MEMORANDUM

To: The Design Advisory Board
From: Mary O'Neil, AICP, Senior Planner
RE: ZP 15-0704CA/CU; 61 Summit Street
Date: January 13, 2015

File: 15-0704CA/CU
Location: 61 Summit Street / 411 Main Street
Zone: I **Ward:** 1
Date application accepted: December 22, 2014
Applicant/ Owner: University of Vermont
Request: Exterior rehabilitation of Alumni House at 61 Summit Street; new construction of a pavilion and connector building; landscaping, pedestrian and vehicular circulation; drainage improvements. Plan includes site alterations to 411 Main Street which will require a separate zoning permit application and review.
Staff site visit: January 5, 2015.

Proj No: 141-030 Drawn: HB
Date: 7/8/14 Ch'd: BR
Sheet Title
**Existing and
Demolition Plan**
Sheet Number

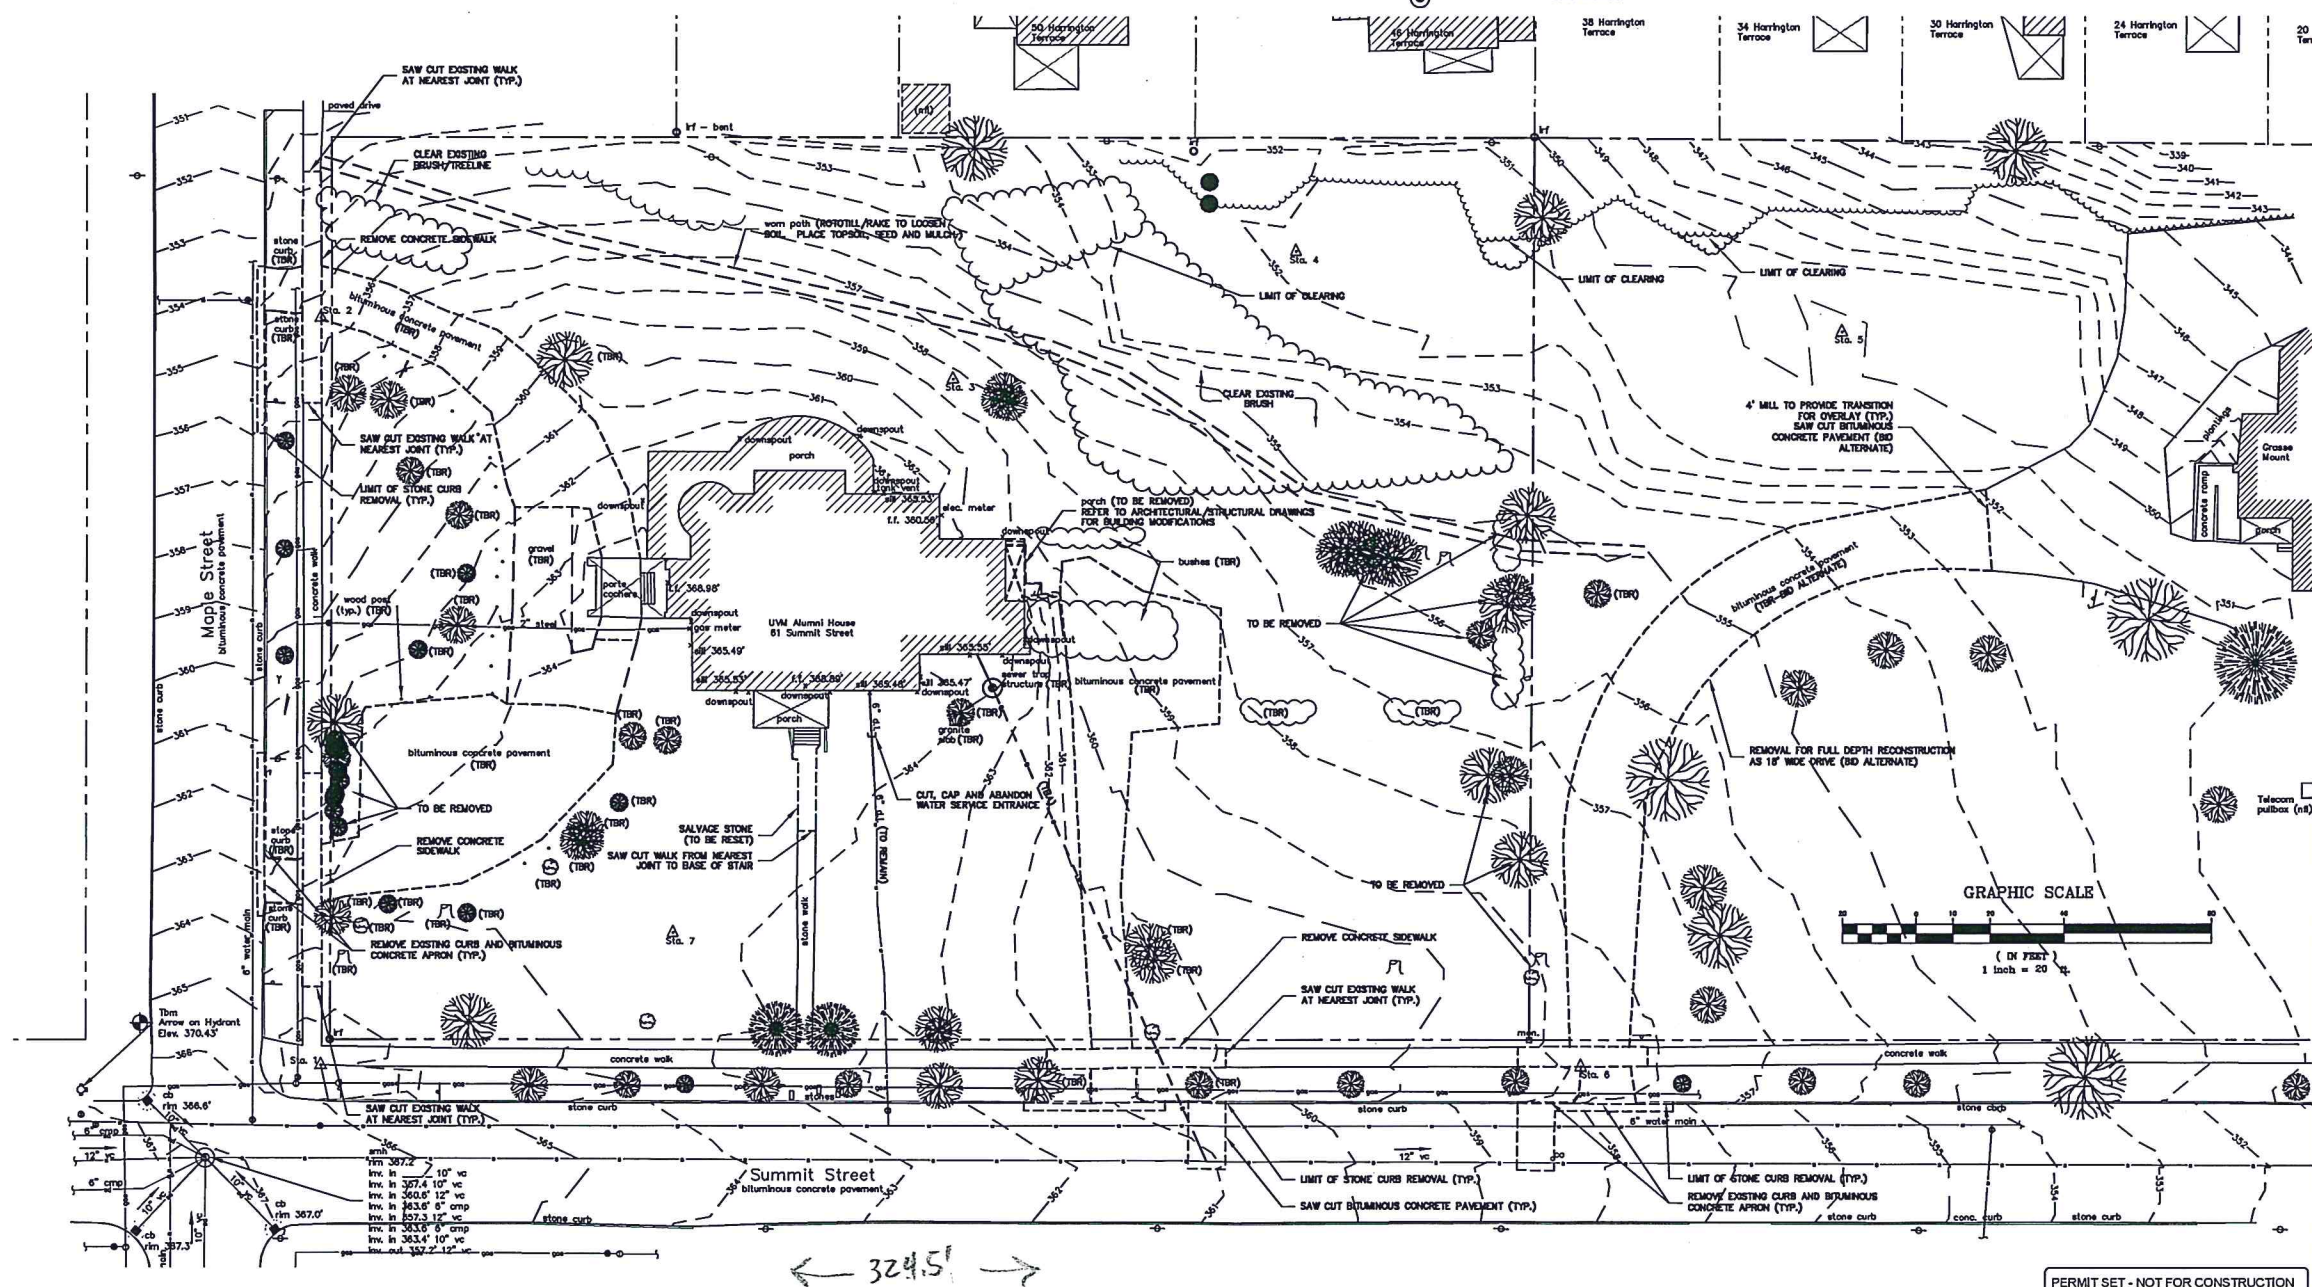
The site falls gradually away to the west, with a collection of large trees both to the west and north. Plan C1.1 defines “clearing existing brush”, however that area has plantings that are so large as to escape definition as brush. No specimen trees are identified on the plan.

Plan C-1.1 notes “clear existing brush”, which appears to be much larger growth than suggested. The City Arborist has been contacted to confirm the characterization of existing growth, and to assure no loss of specimen trees in the area of development.

C-1.2

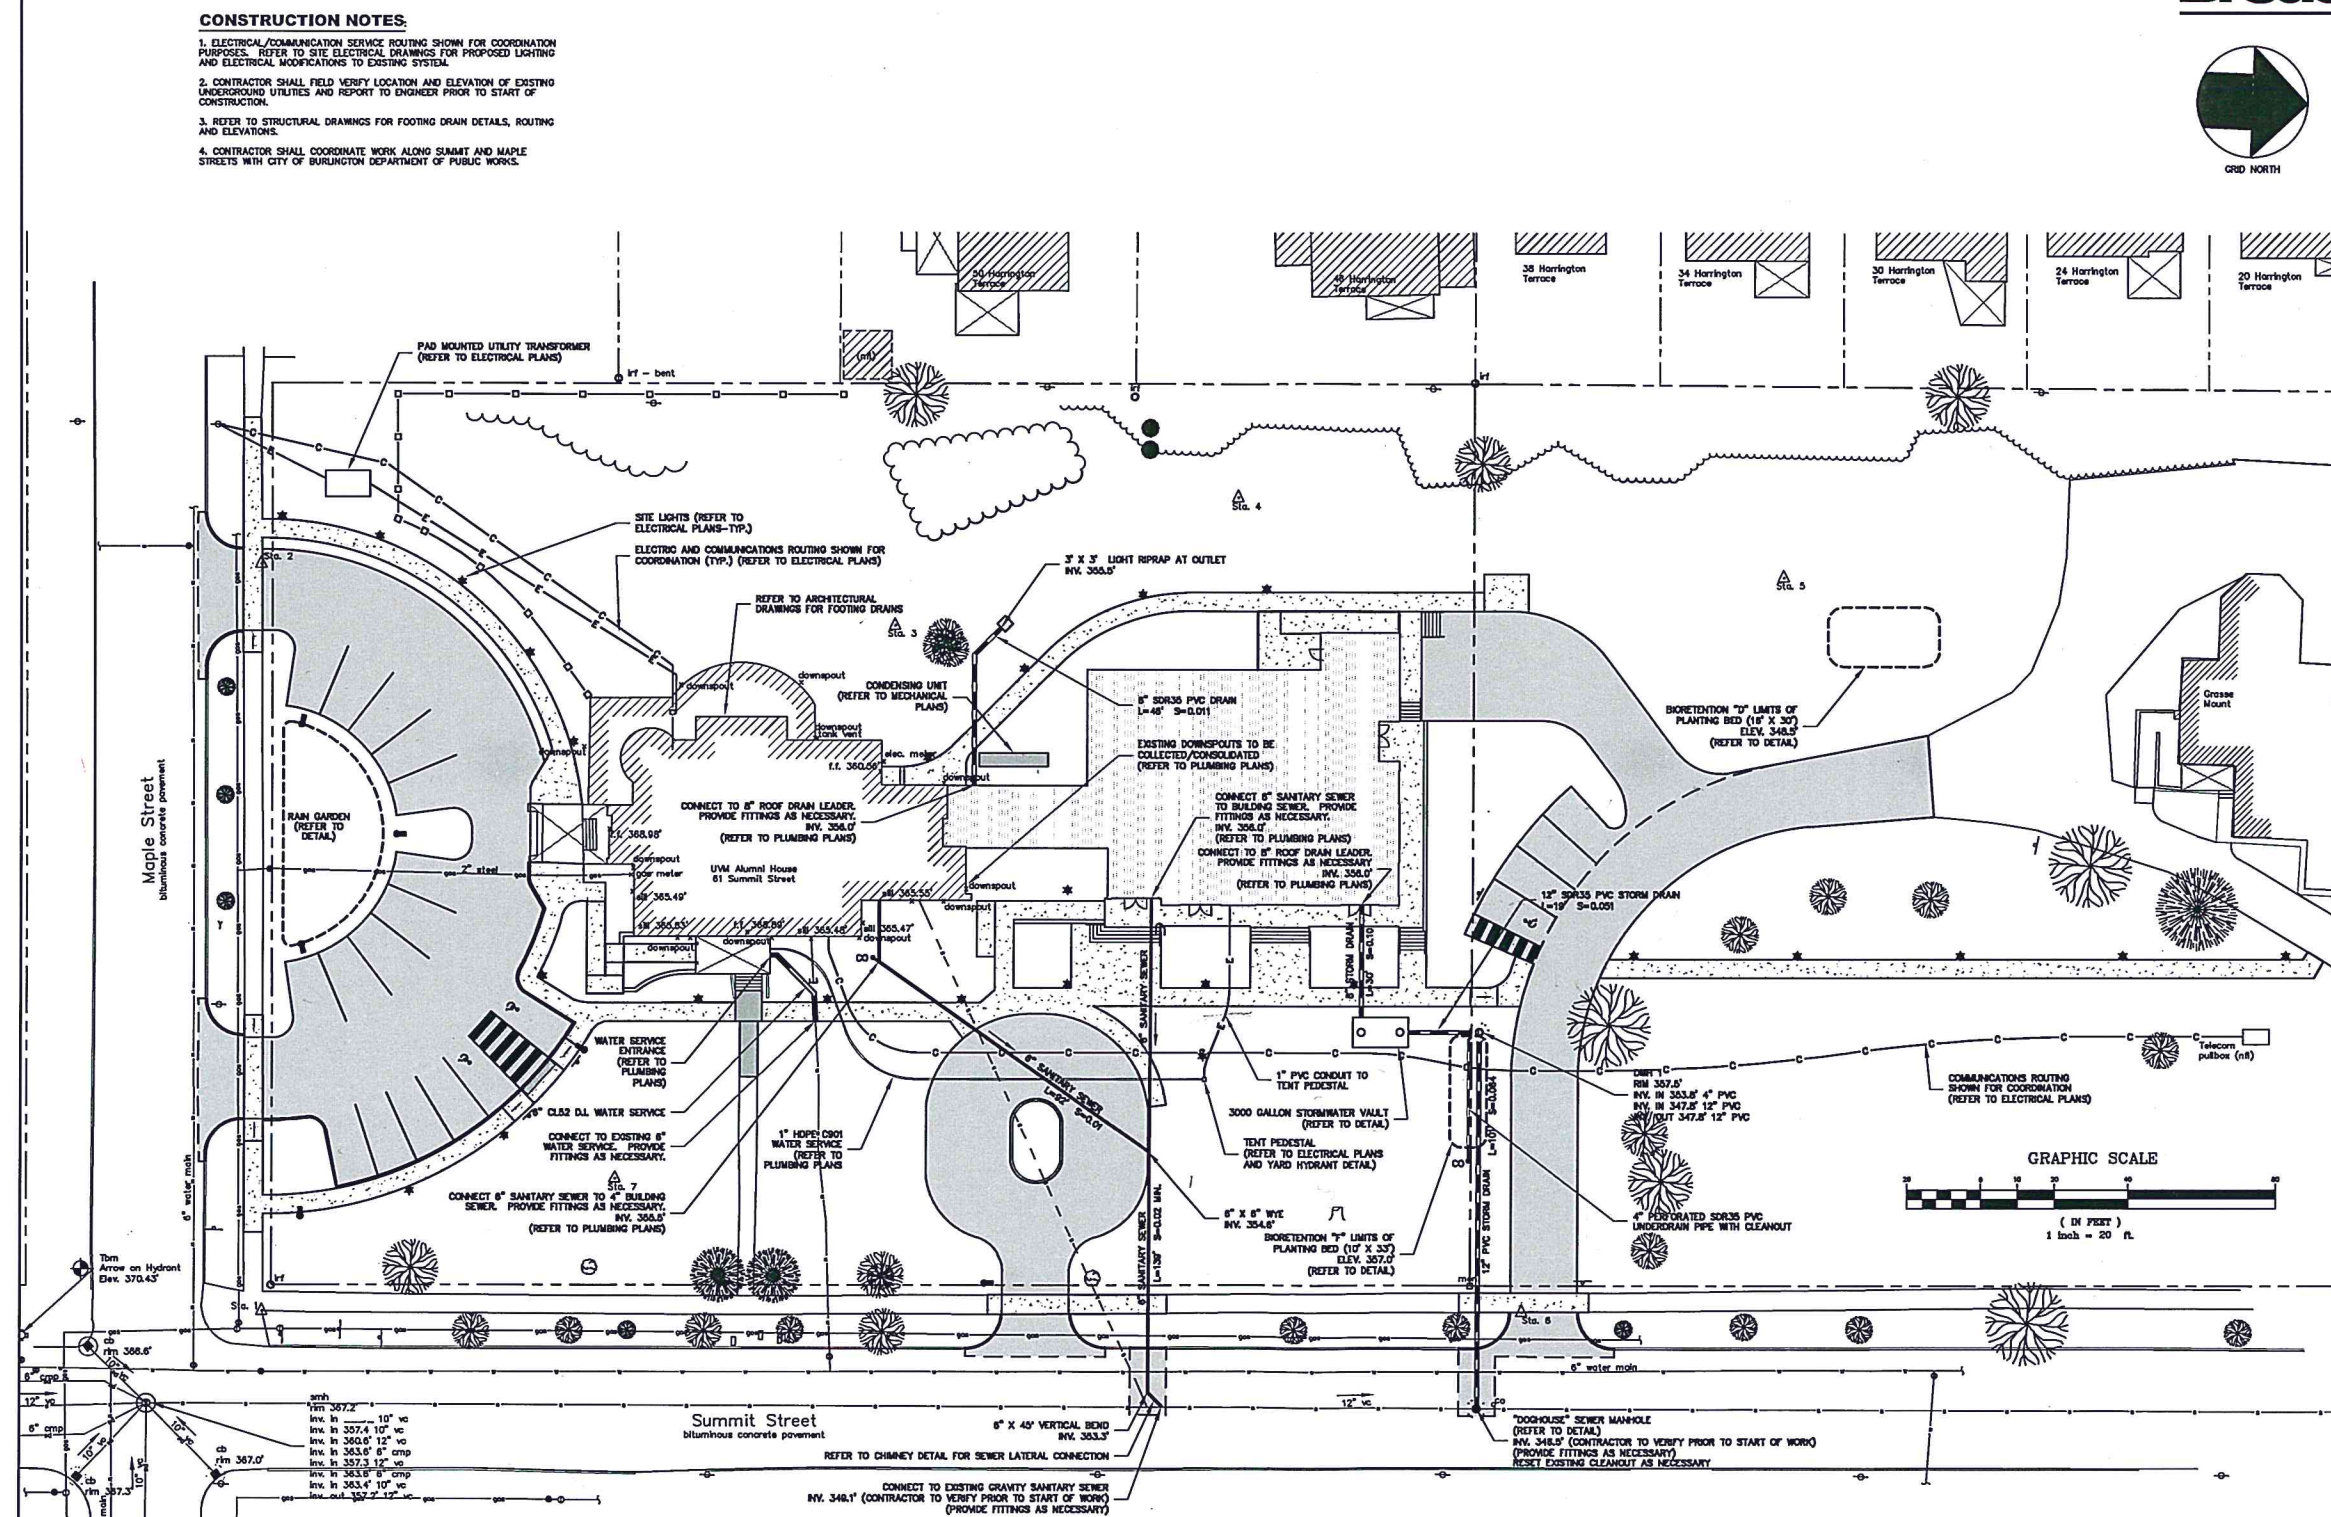
A general utility “clean-up” at 61 Summit is reflected in the submission (See Plan A4.1, A4.2, A4.3, A4.4) with removal of existing electric meter, conduit and flood lights. Masonry and trim are proposed to be repaired. Plan C-1.2 defines the gas meter on the south elevation of 61 Summit inside an area defined by the access ramp. Landscaping should be utilized to minimize the visual impacts of what is likely to be a large meter.

A1.1

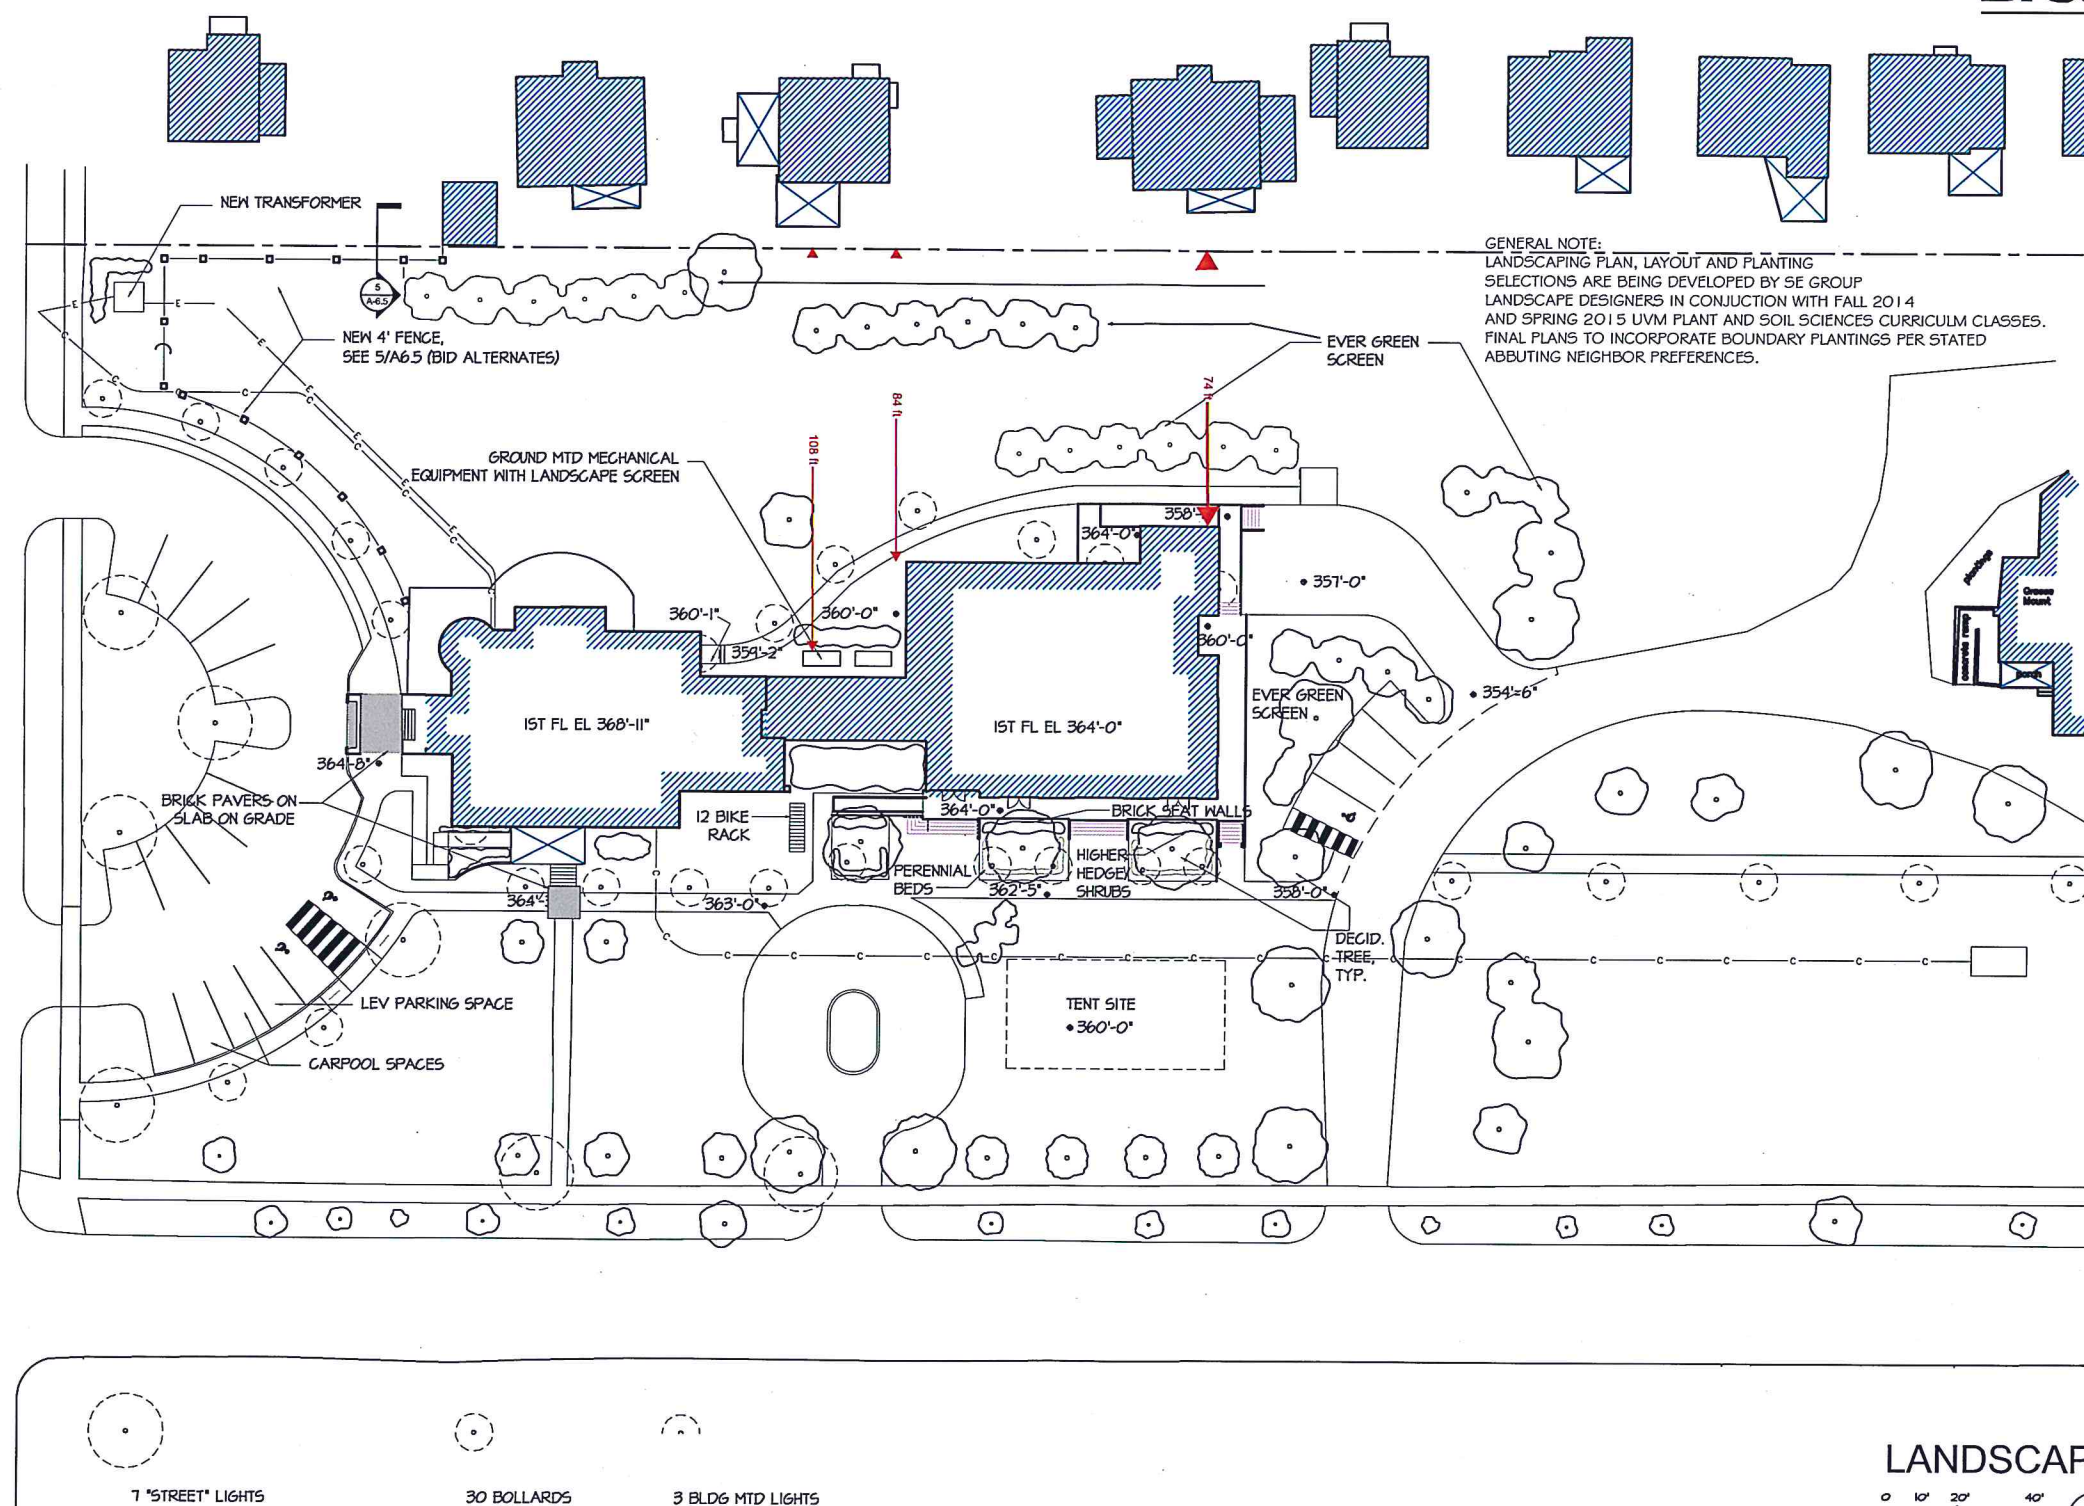
A bicycle parking rack is illustrated on Plan A1.1.

The landscaping plan (A1.1 is vague in defining proposed installation: General Note states: *Layout and planting selections are being developed by SE group Landscape Designers in conjunction with Fall 2014 and Spring 2015 UVM Plant and Soil Sciences Curriculum Classes.* Although encouraging, this is not informative enough for project review. More specificity is required.

From Plan A1.1, it appears that the fence does not meet the required 25' separation from the westerly driveway entrance, as illustrated below. If the fence location is important to the plan, then the fence must be reduced in height to 3' if within that "clear site triangle."

Building mounted lights are historically-inspired; other site lighting is proposed to be LED. Bollard lighting is proposed along walkways; seven new light poles will be included. See Plan A1.1. Photometrics appear to meet the standards of Section 5.5.2.

1. The applicant shall confirm the proposed size of parking spaces, to assure compliance with Table 8.1.11-1.
2. A definitive landscaping plan must be submitted, identifying proposed layout and selection.

4. Fence placement must meet the Clear Site Triangle as noted in 6.2.2. (m.), above.
5. A separate zoning permit application must be filed for the 411 Main Street parcel.

5 Boundry Fence Detail (Bid Alternate)

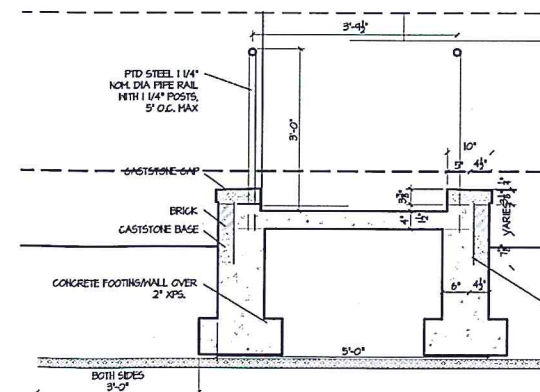
A 4' fence is illustrated on the southwest of the parcel; presumably to ban pedestrian foot traffic in the existing pattern of use. See Plan A6.5 for detail drawing.
